APPLICATION NO.	FILING DATE	FIRST NAMED INVENTOR	ATTORNEY DOCKET NO.	CONFIRMATION NO.
10/702,614	11/07/2003	Noriyuki Komatsu	00684.003558	8523
5514	7590	06/19/2006	EXAMINER	
FITZPATRICK CELLA HARPER & SCINTO 30 ROCKEFELLER PLAZA NEW YORK, NY 10112				JIMENEZ, MARC QUEMUEL
ART UNIT		PAPER NUMBER		
3726

Office Action Summary	Application No.	Applicant(s)
	10/702,614	KOMATSU ET AL.
	Examiner	Art Unit
	Marc Jimenez	3726

DETAILED ACTION

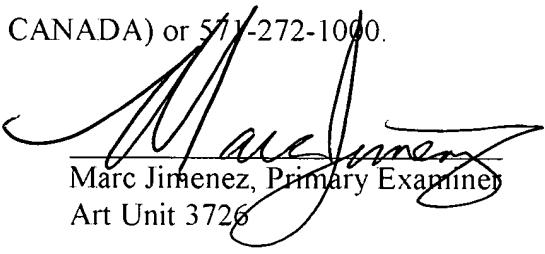
Regarding claim 4, note the cop-away portion **50**.
